Addendum No. 02

Issued: 9/13/2024

Project Name: Jordan Learning Center
Project No.: 2024528.00
Bid Package: 1

SHEET NUMBER
SF201

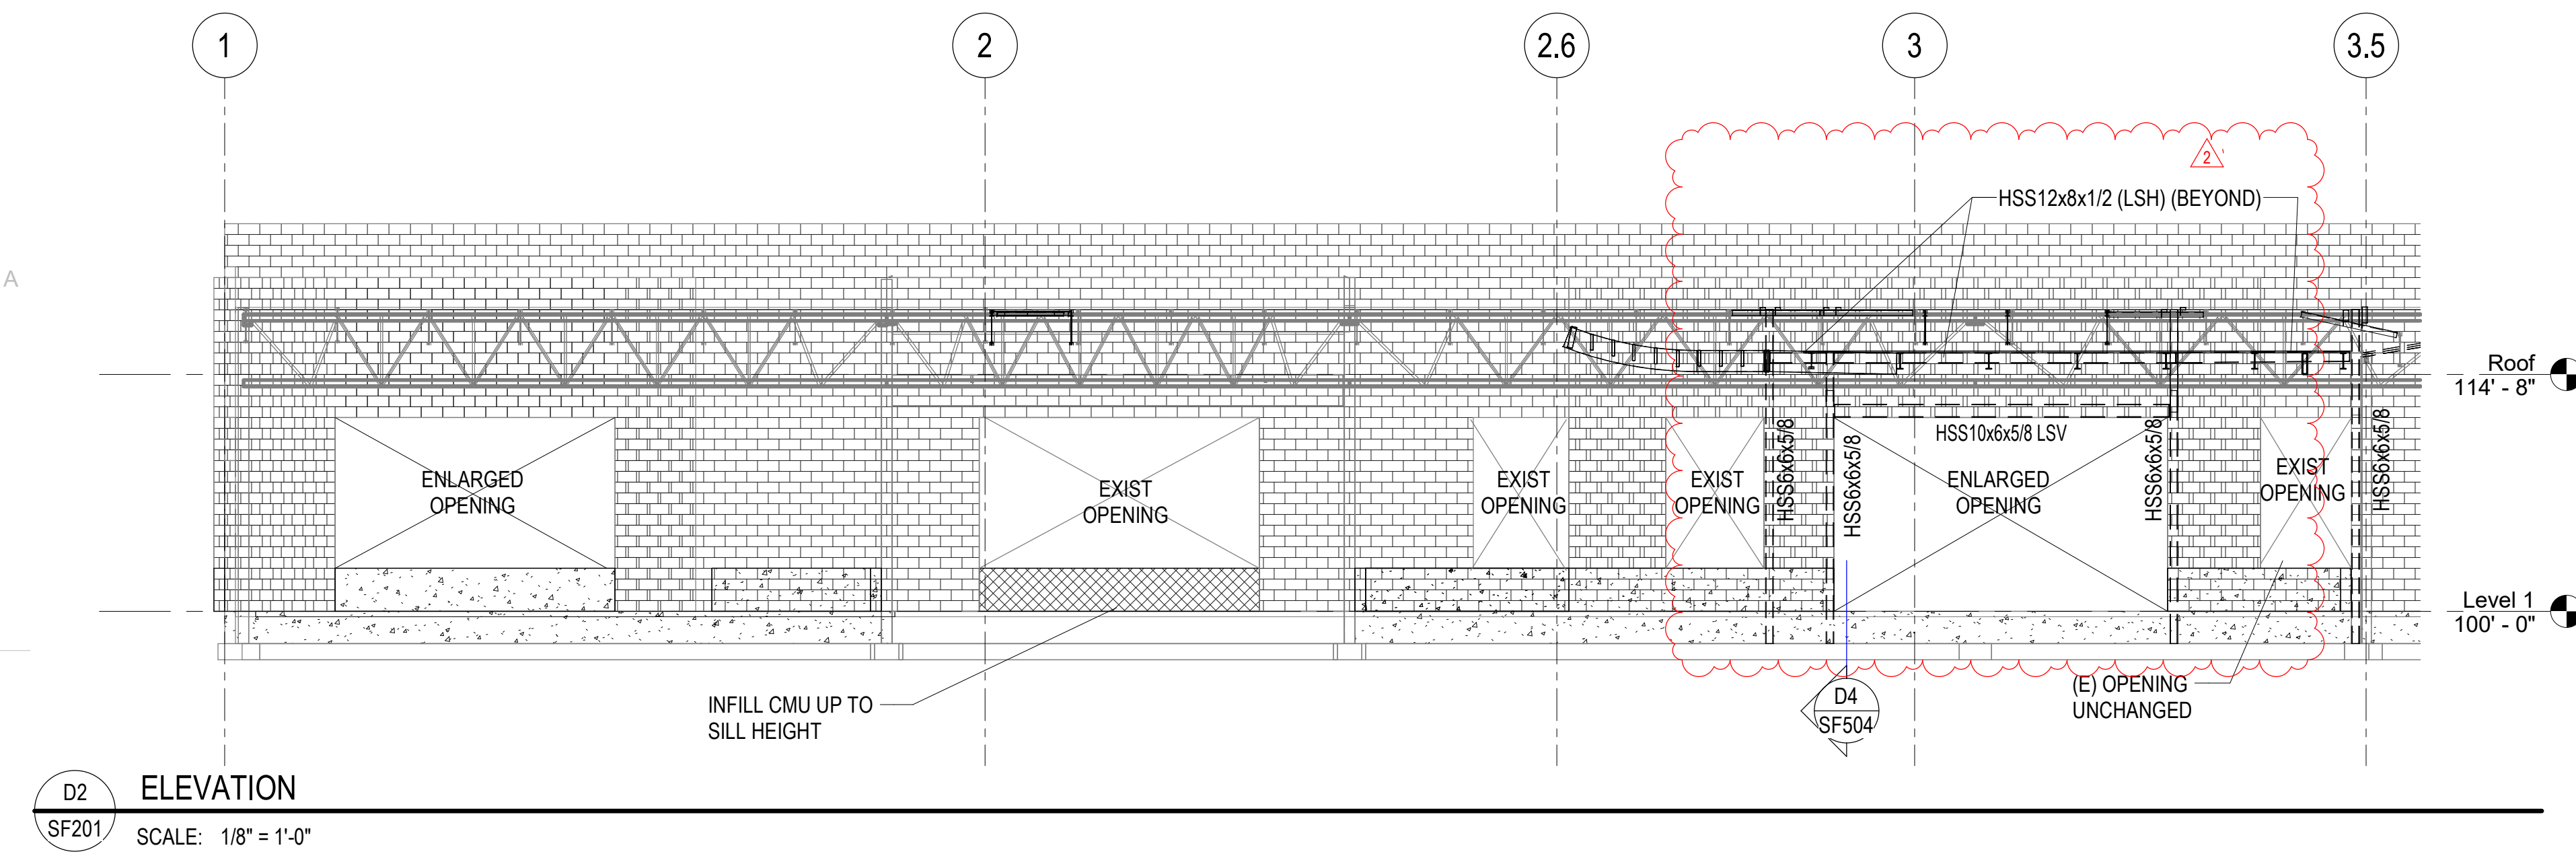
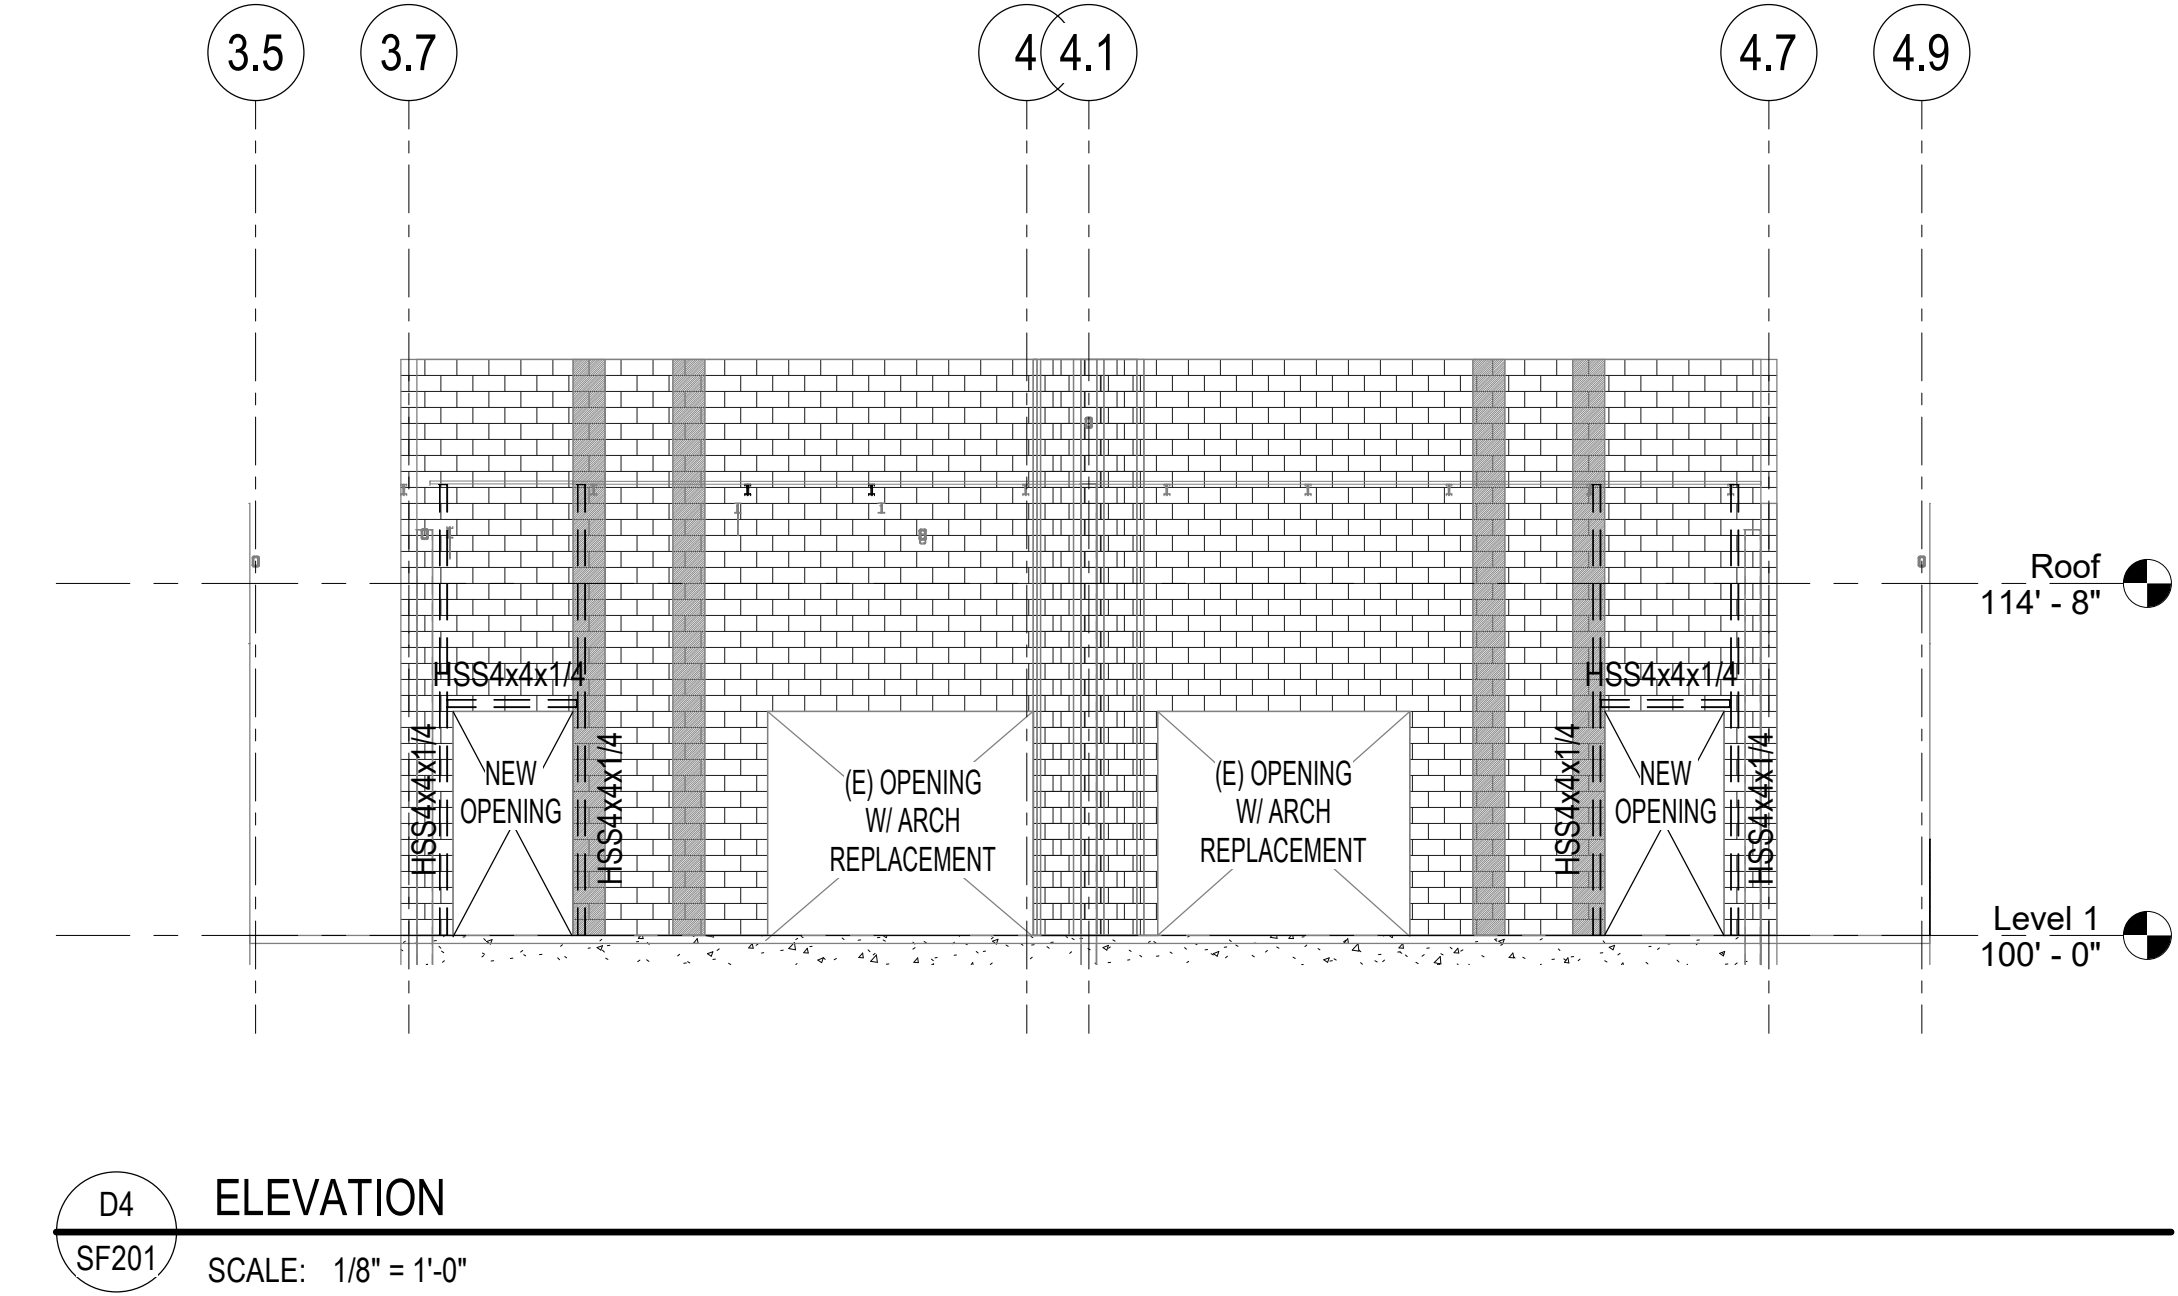
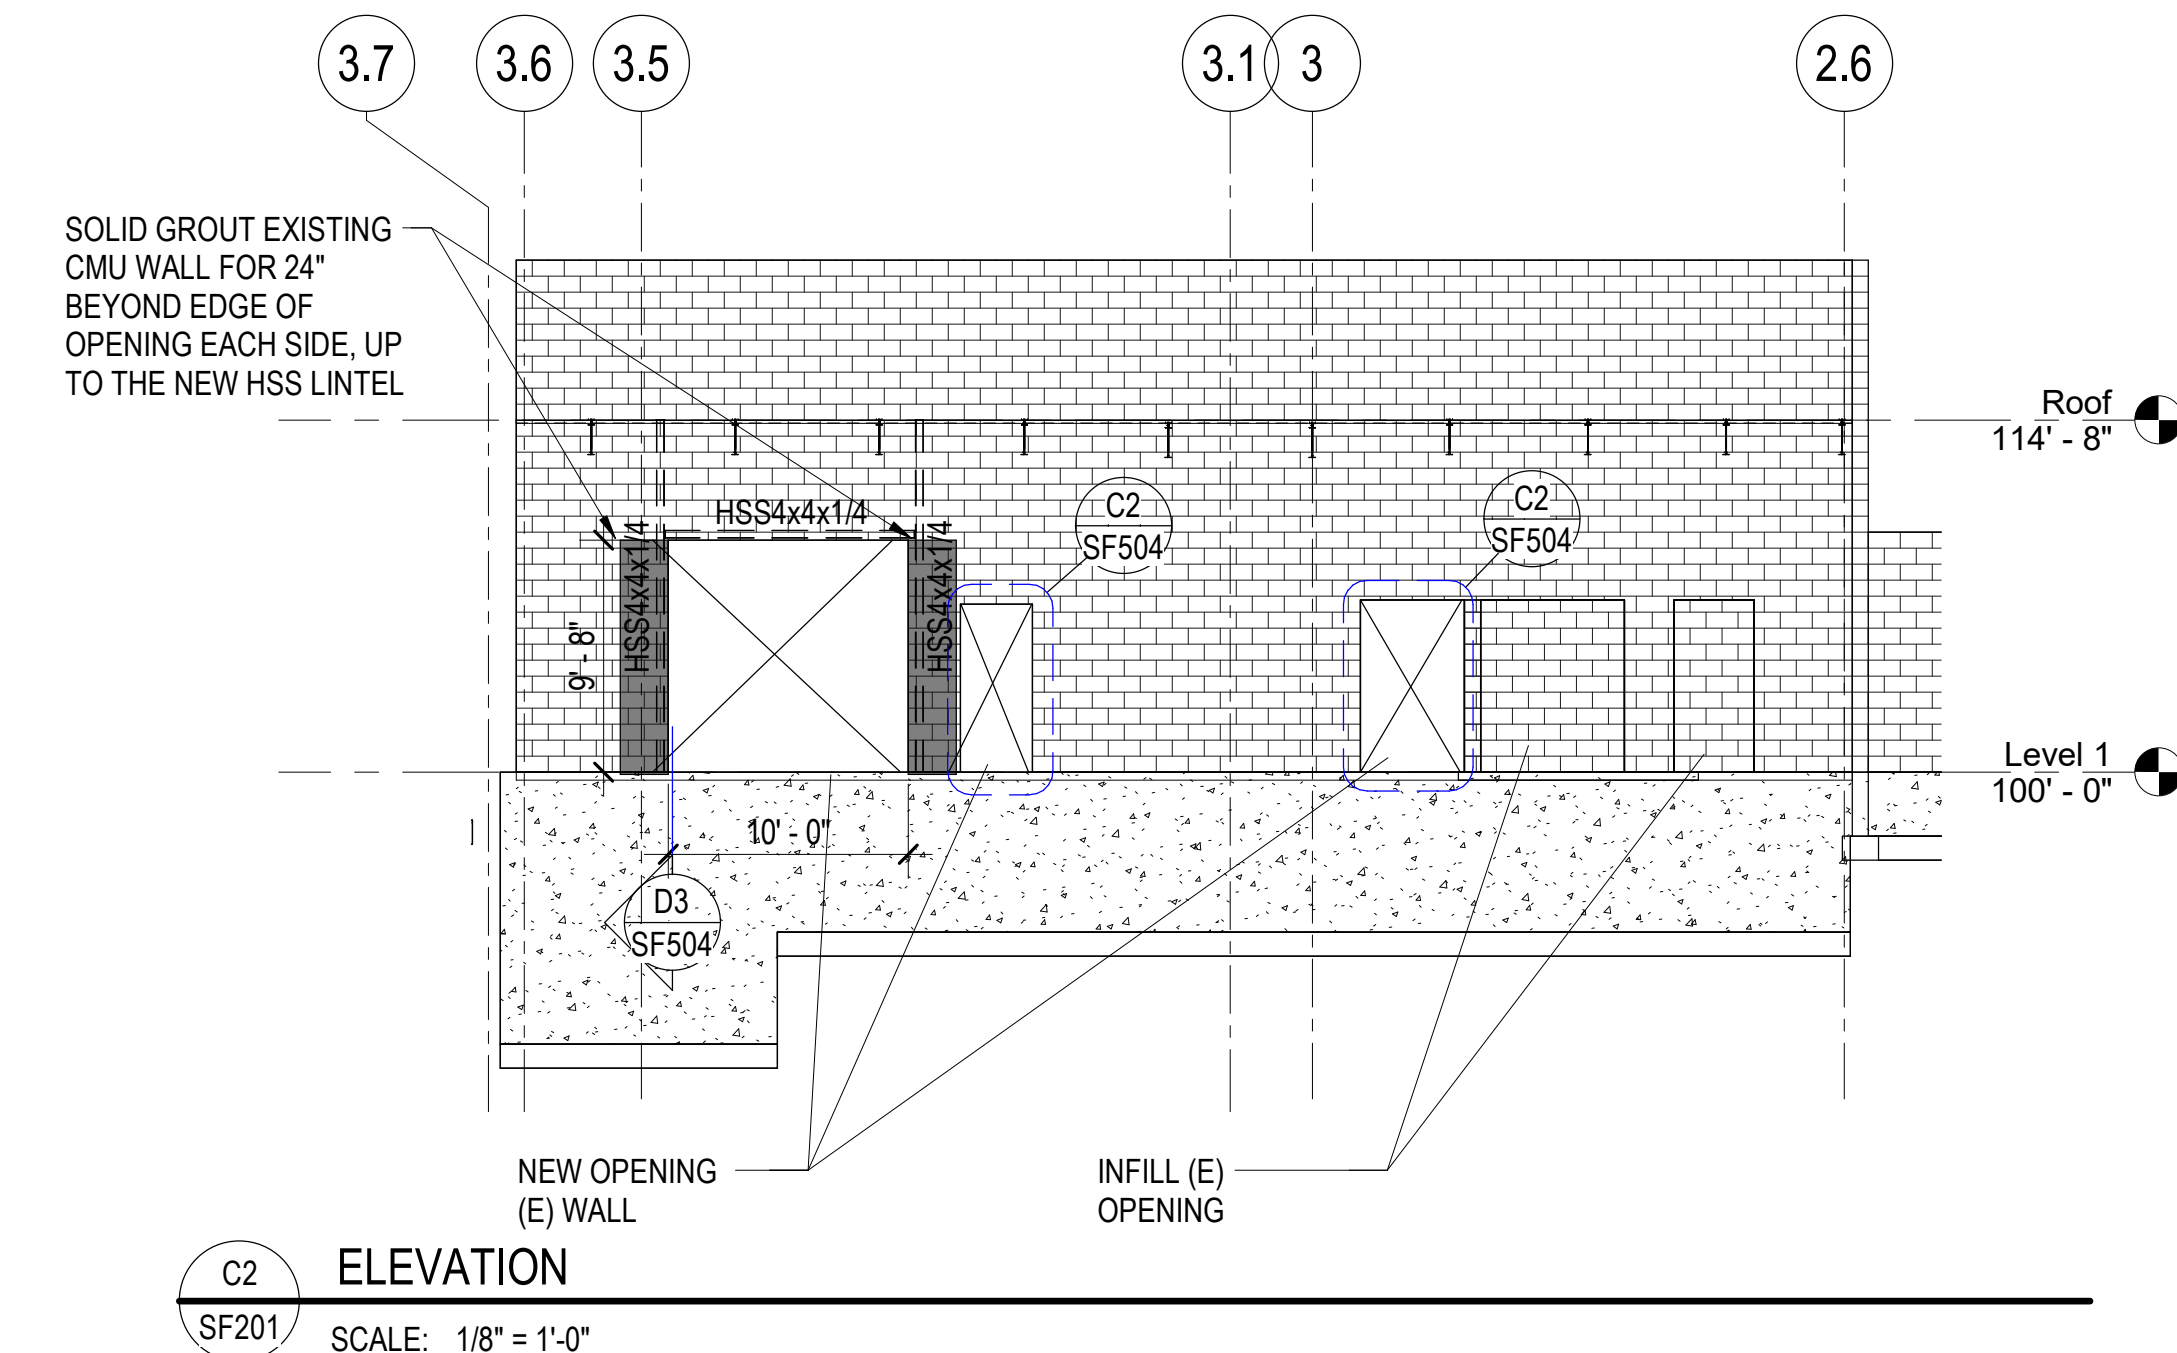
- Added the additional setback tube columns and HSS lateral support per SF101A and B.
